Plans Review
Municipality of Mississippi Mills
Building Dept.
2022-07-07

May 31, 2022

Re: Proposed Single Family Dwelling, 288 Antler Court, Lot # 47 White Tail Ridge, Arnprior, Kollaard Associates File # 220020

With regard to structural issues only, Kollaard Associates has reviewed the following drawings:

JOB:
PHOENIX HOMES
WHITE TAIL R/
WTR3-47
NEWINGTON
1ST FLOOR

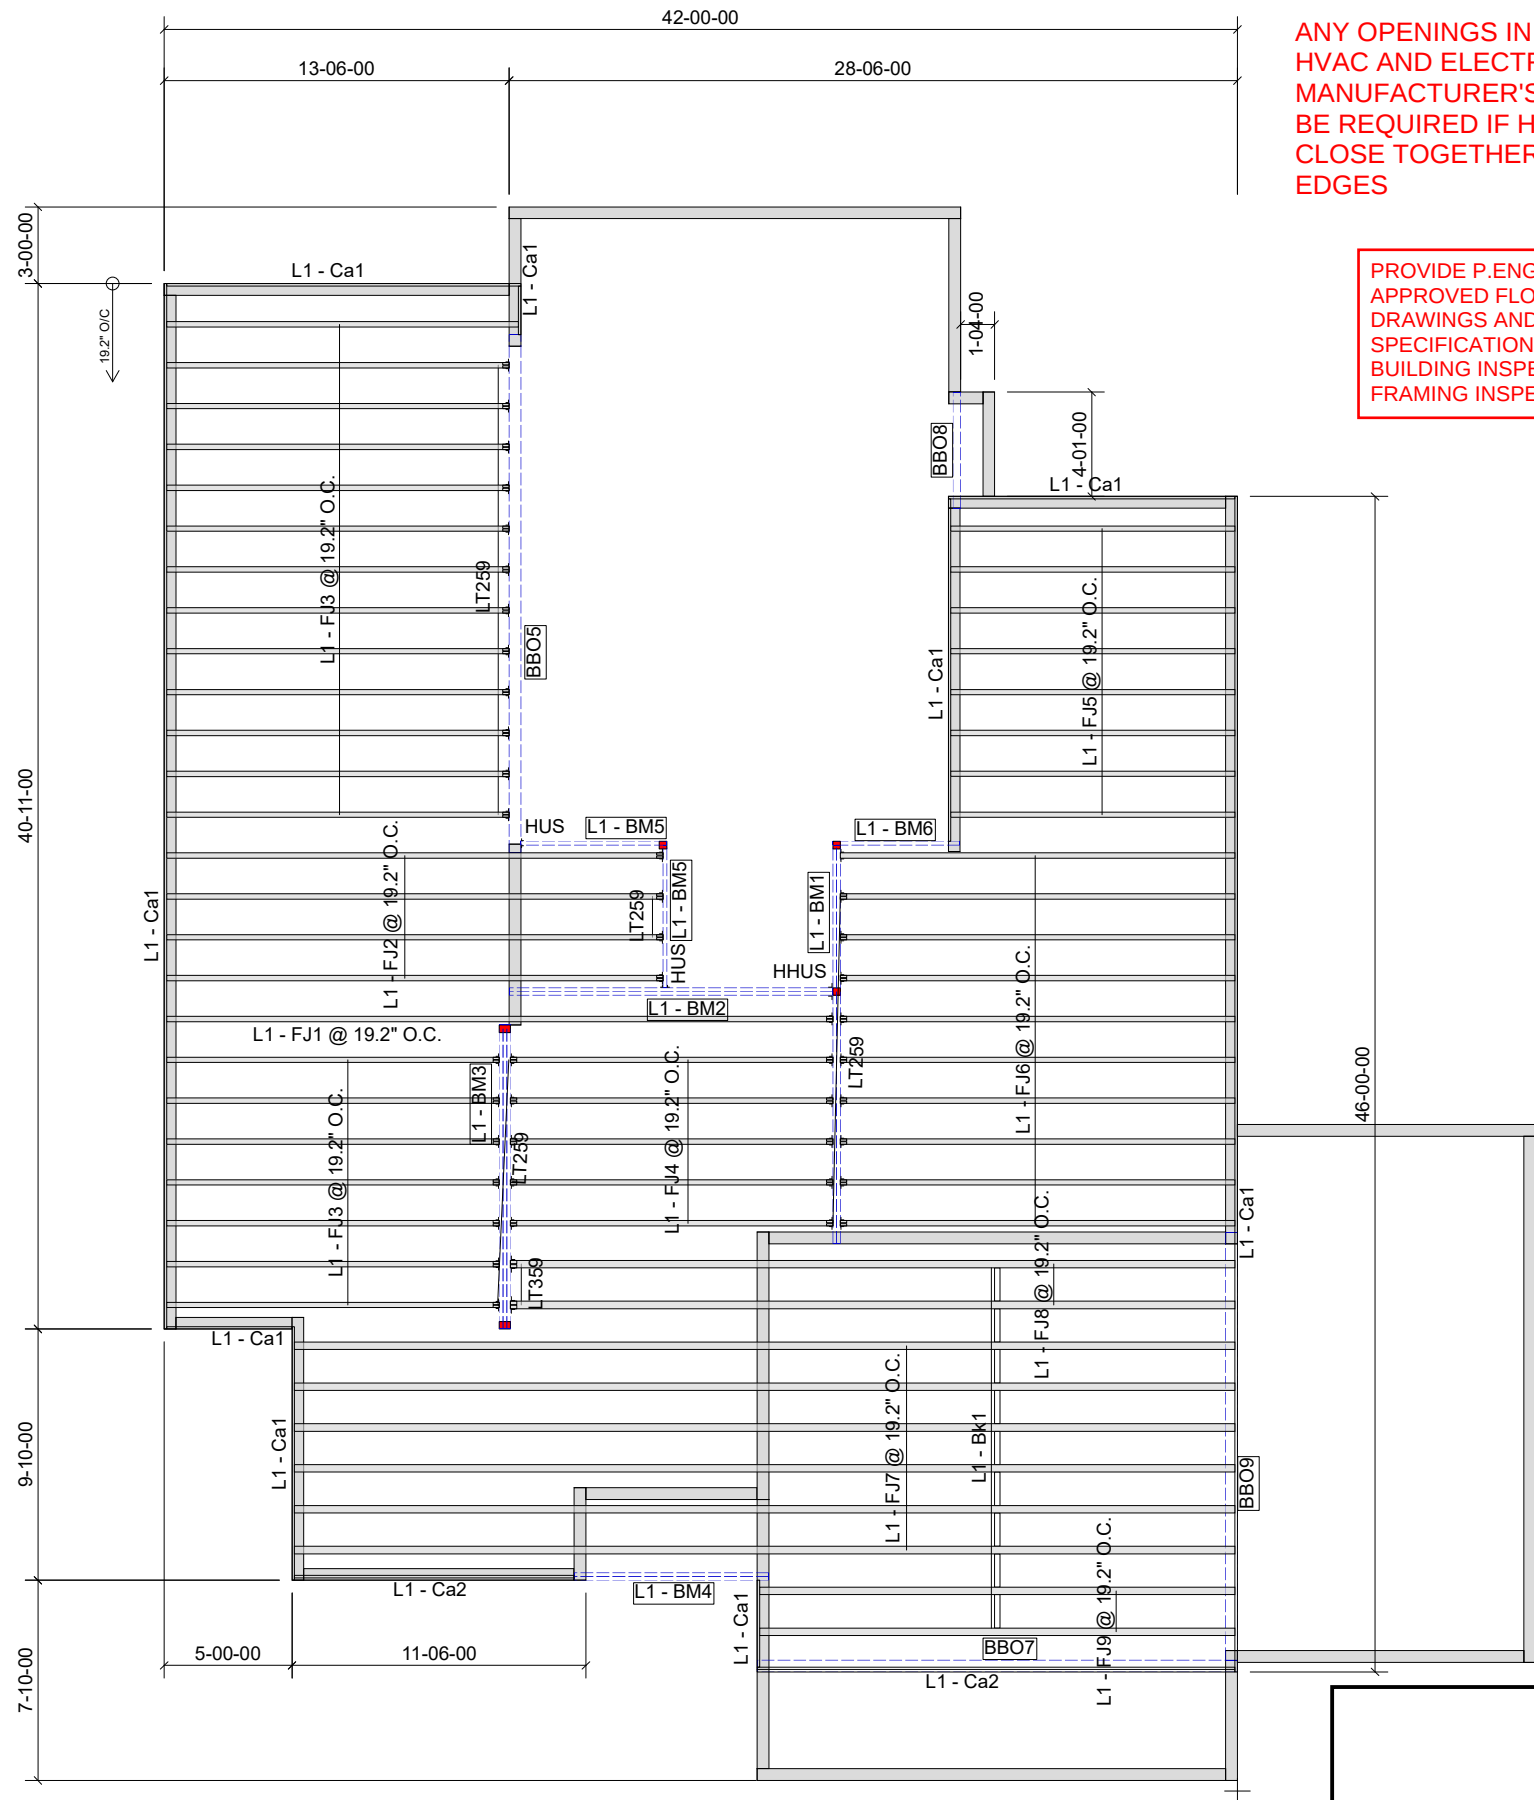
20. The floor joist layout is to be revised to specify the flush window lintels as shown on Phoenix Homes Sheet # 2M.

GROUND FLOOR PLAN (M ELEVATION)
1782 SQ. FT.

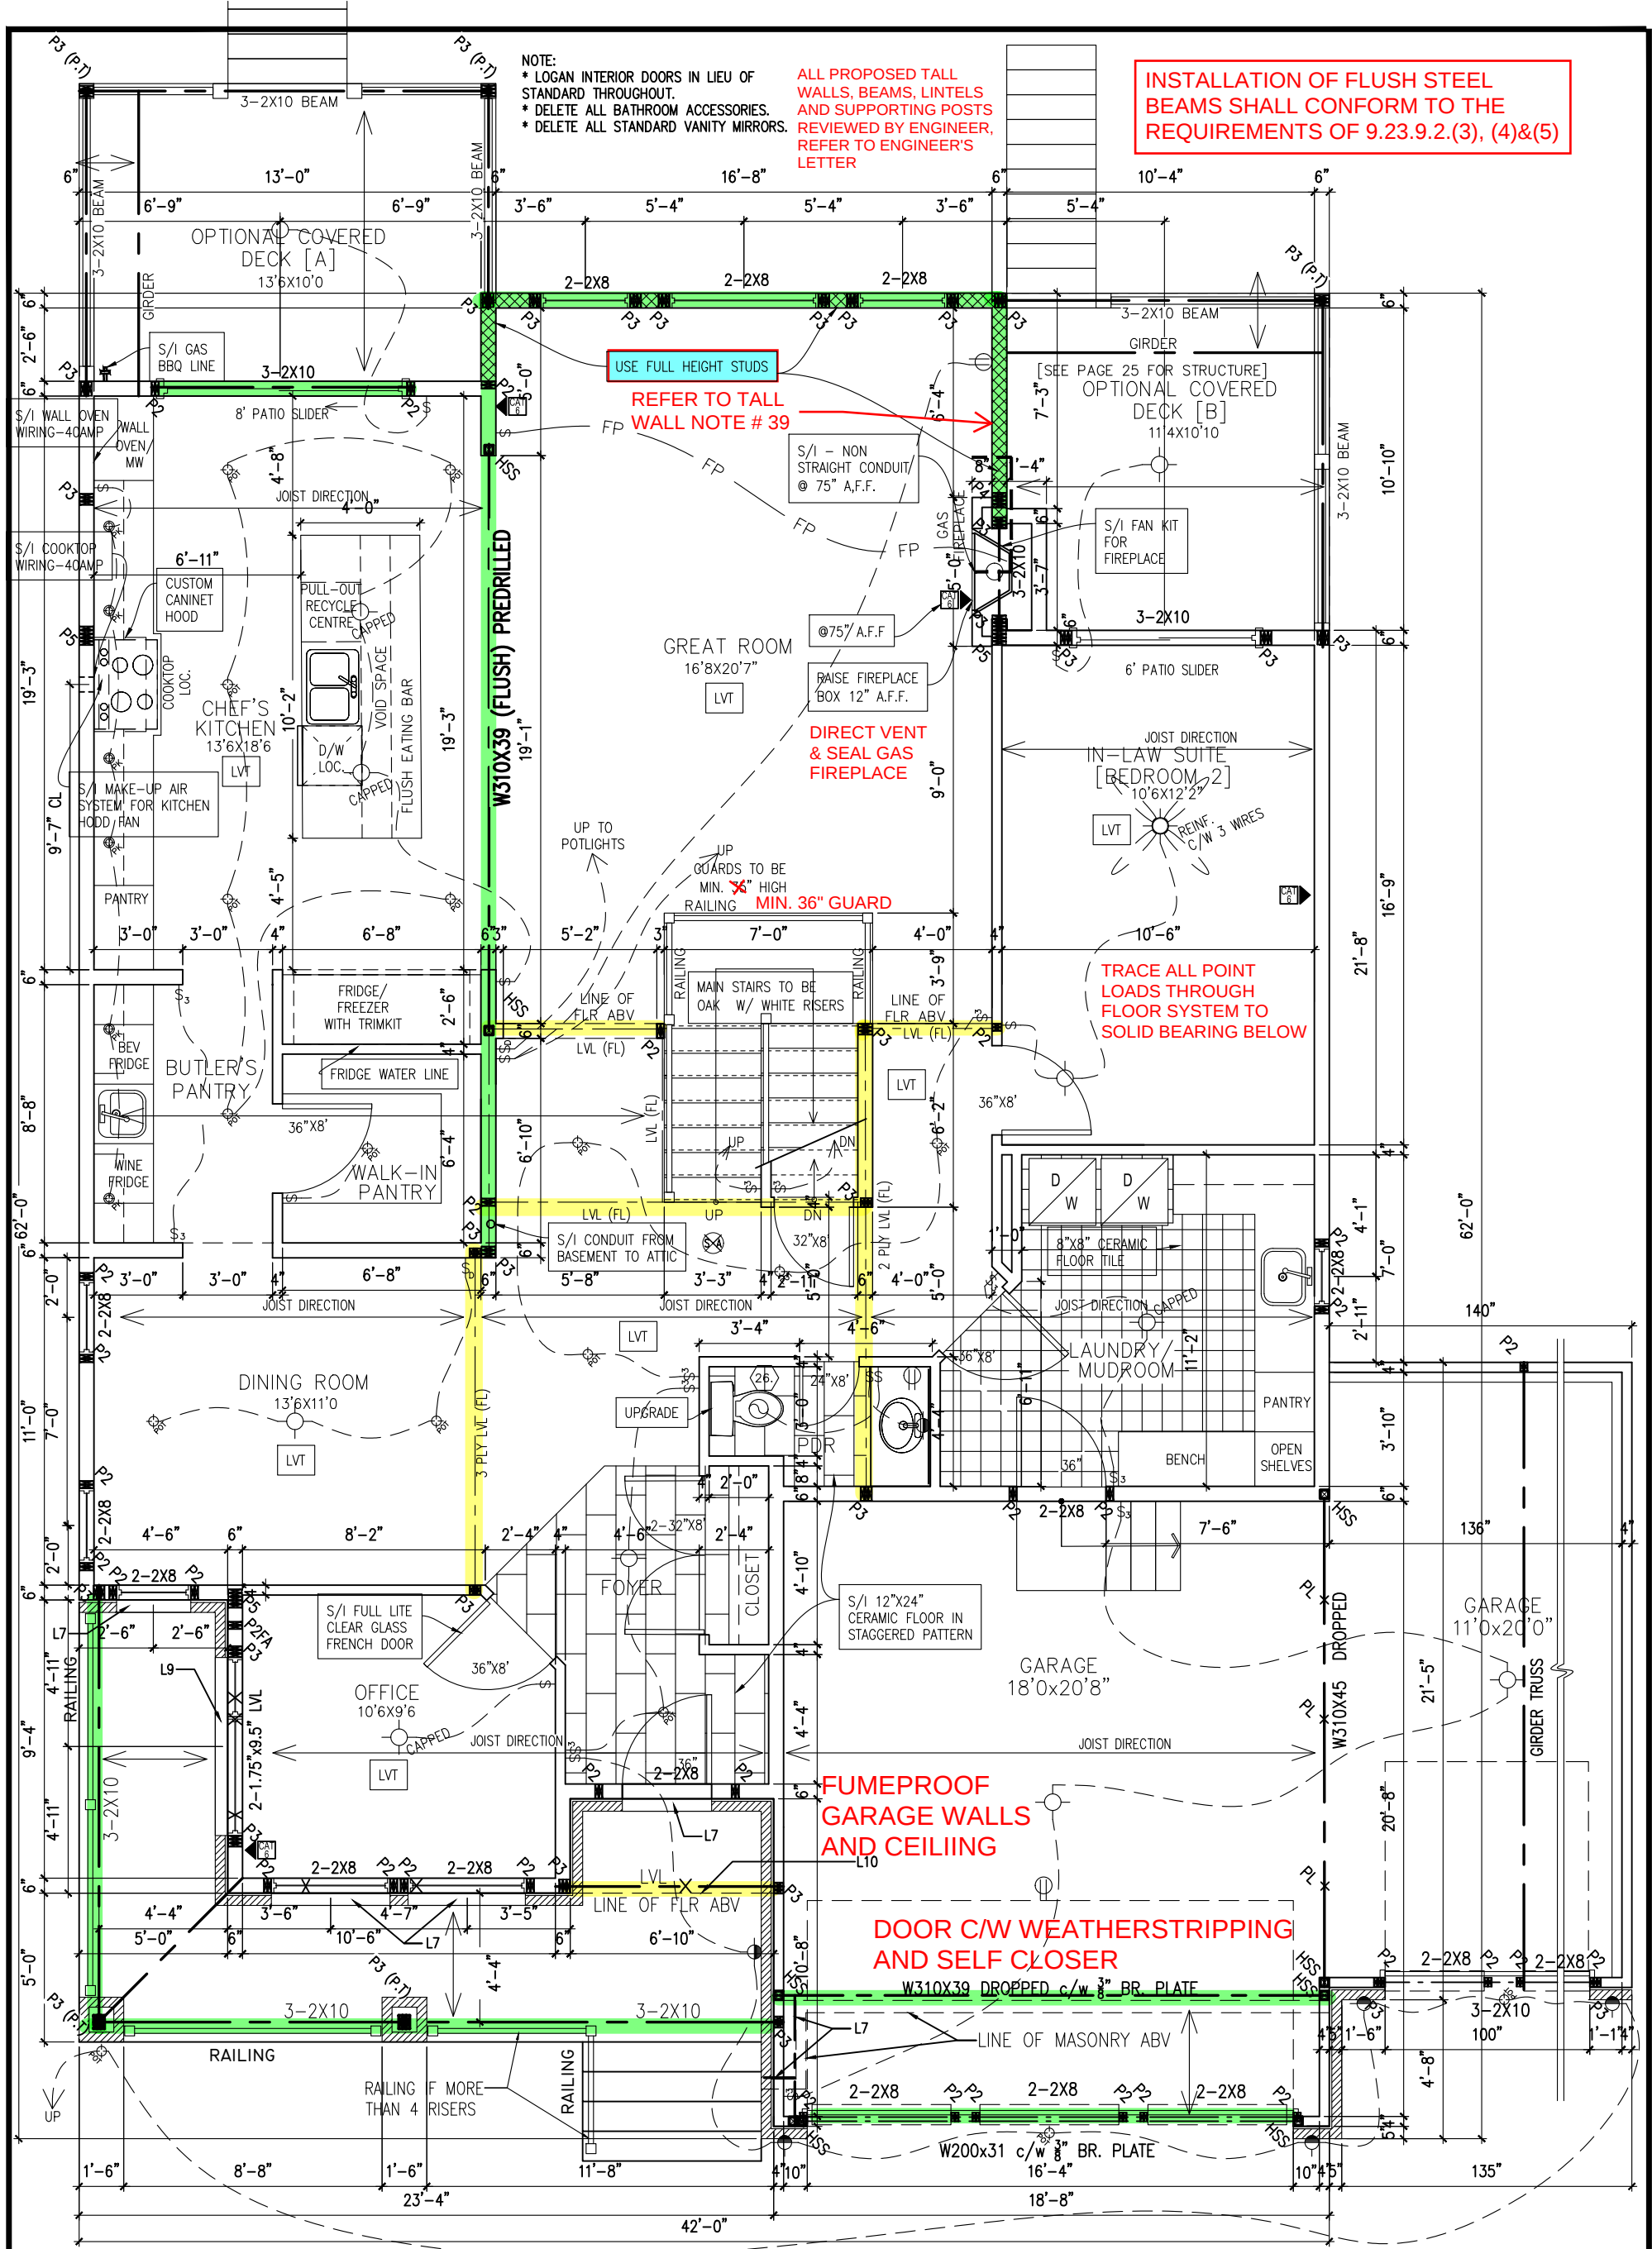
Ground Floor Plan – Pages # 3M:

5. It is the opinion of Kollaard Associates that the proposed lintels, beams and supporting posts shown on Phoenix Homes Pages # 3M are adequate

6. Ramset a 2x6 to the top flange of all steel beams to attach the above framing, floor joists and flush LVL beams.
7. The proposed web packing of the steel beam detailed on Phoenix Homes Sheet # 8M is adequate.
8. Truss design is by others.
9. Posts supporting girders may consist of built up 2x6 posts as indicated on Phoenix Homes Pages # 3M and are laterally supported by plywood or OSB sheathing (i.e. posts form part of sheathed exterior walls unless noted).
10. Floor joist design and flush LVL beams within the floor structure are by the manufacturer.

SECOND FLOOR PLAN (ELEVATION M)
1672 SQ. FT.

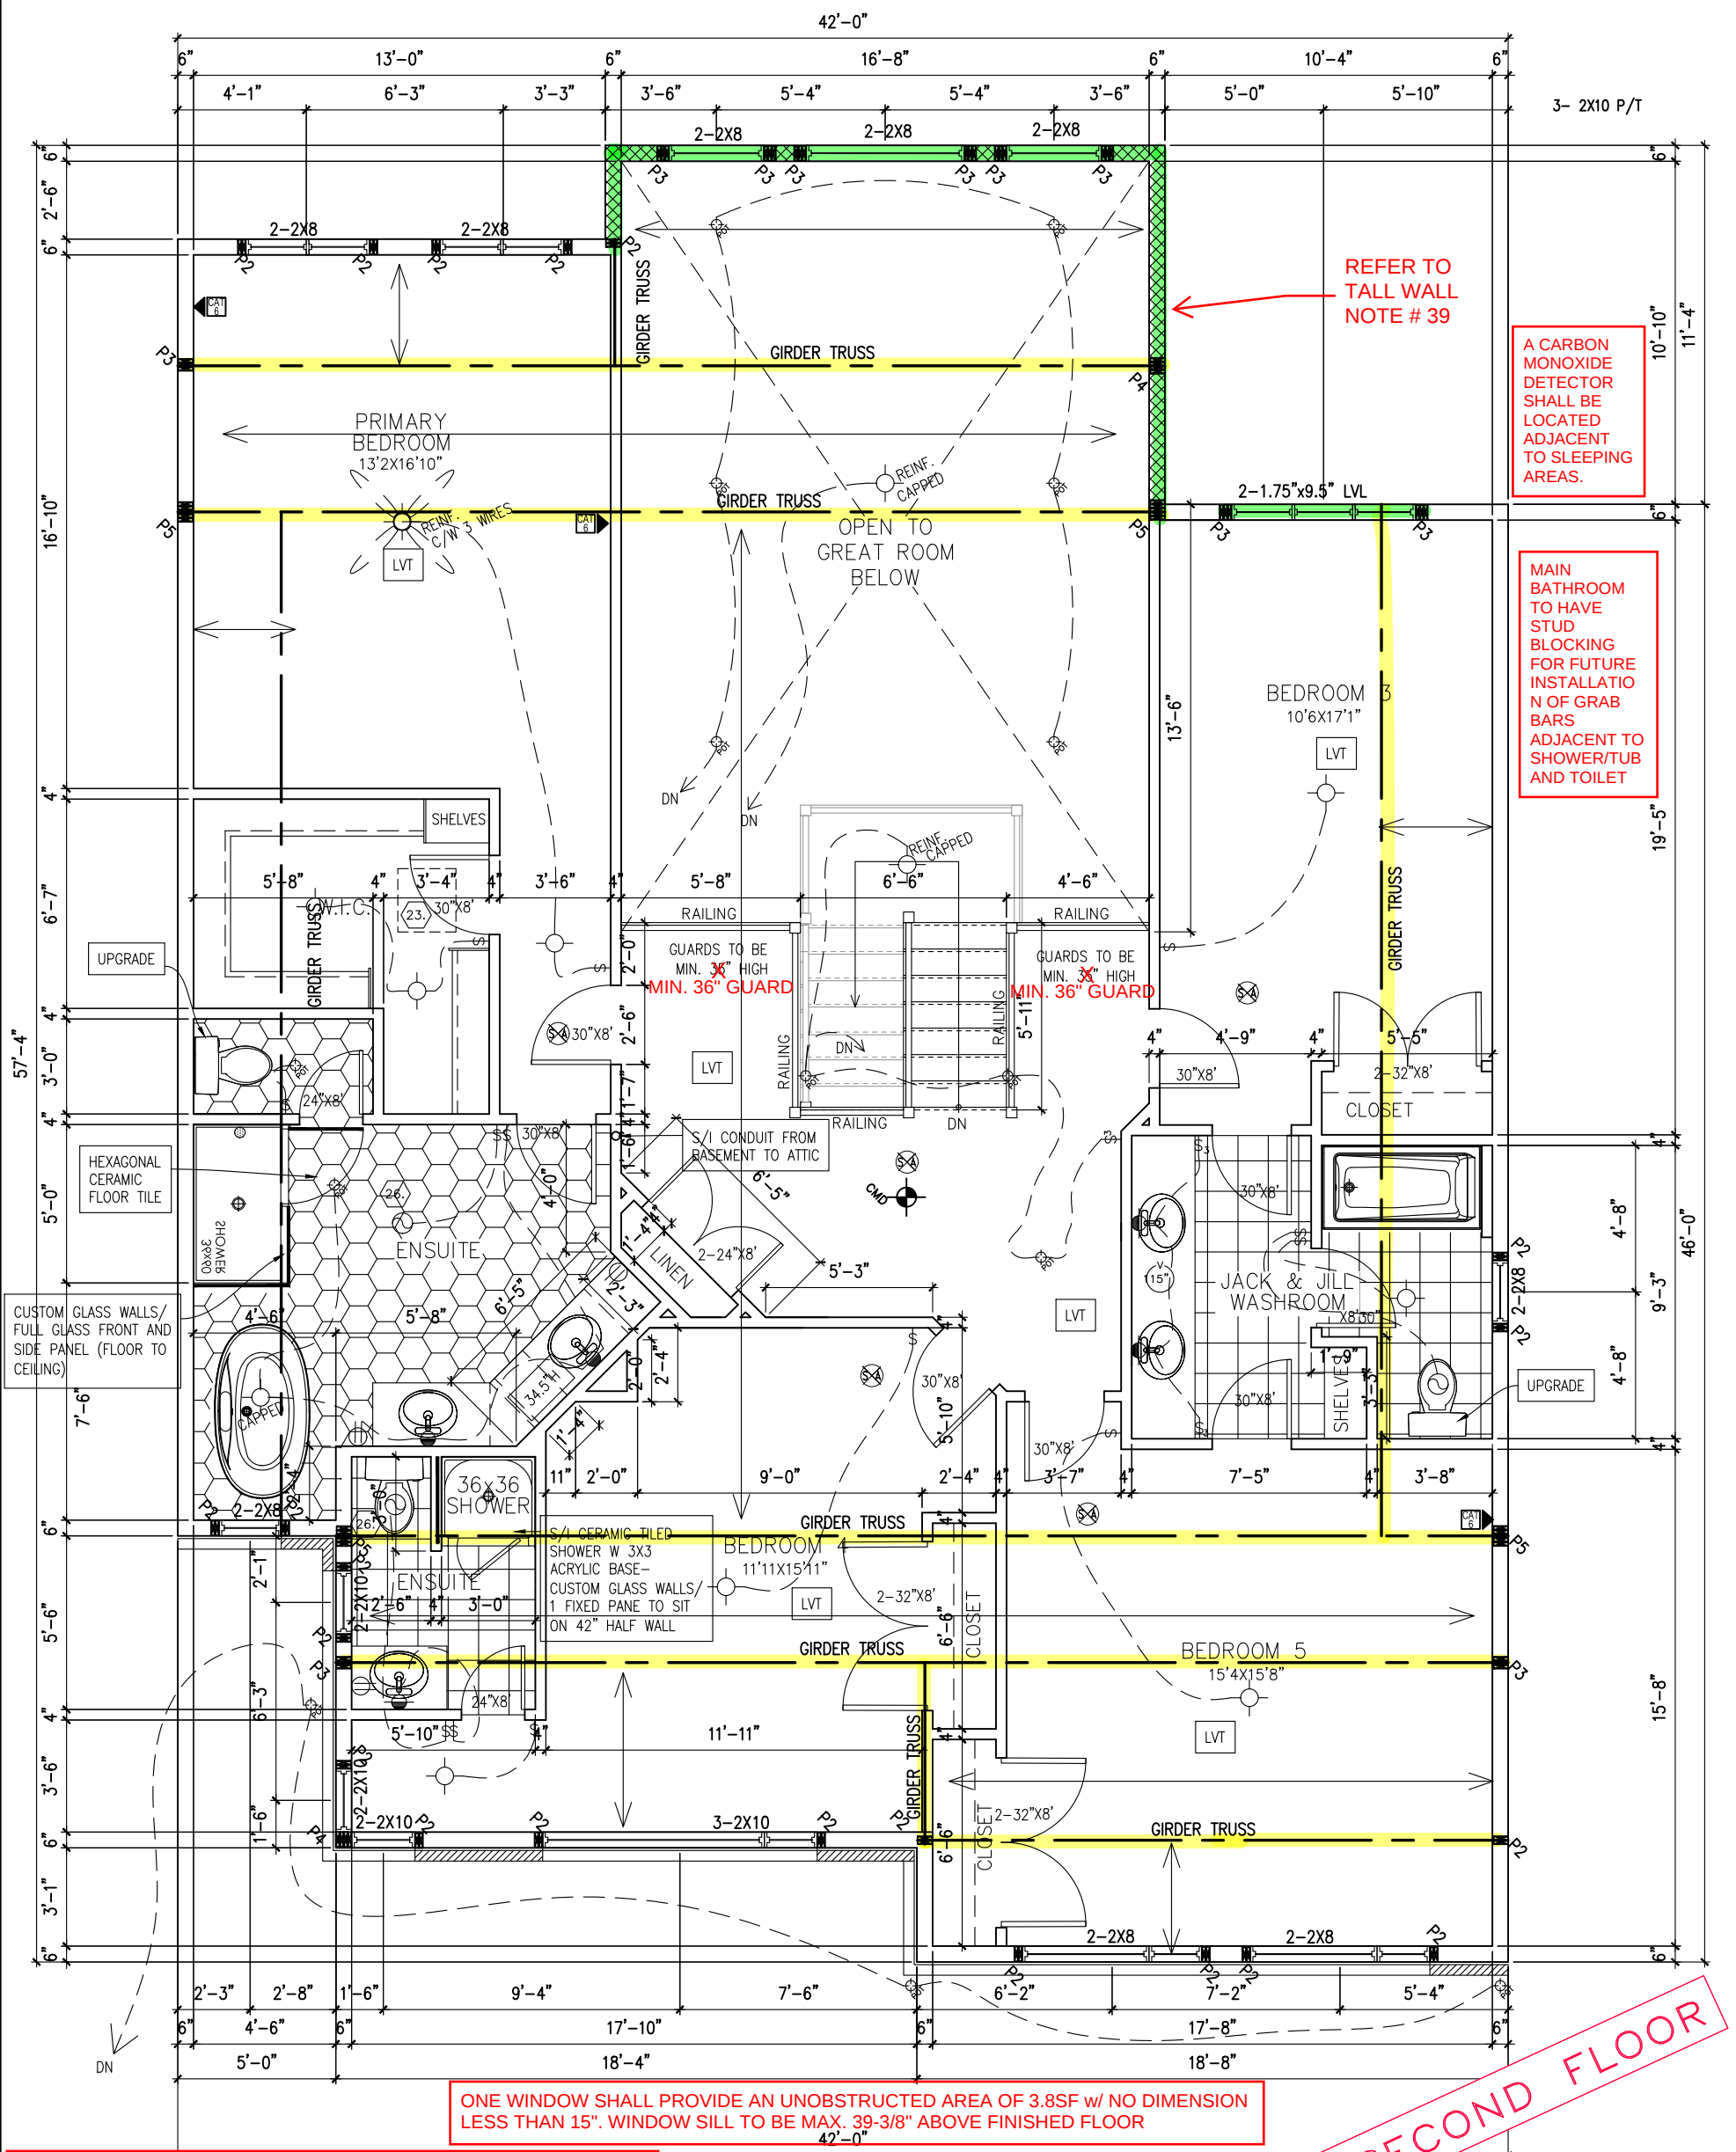
Second Floor Plan – Pages # 4M:

1. It is the opinion of Kollaard Associates that the proposed lintels and supporting posts shown on Phoenix Homes Pages # 4M are adequate.
2. The proposed tall wall noted on Phoenix Homes Pages # 1M is adequate.
3. Posts supporting girders may consist of built up 2x6 posts as indicated on Phoenix Homes Pages # 4M and are laterally supported by plywood or OSB sheathing (i.e. posts form part of sheathed exterior walls unless noted).
4. Truss design is by others.
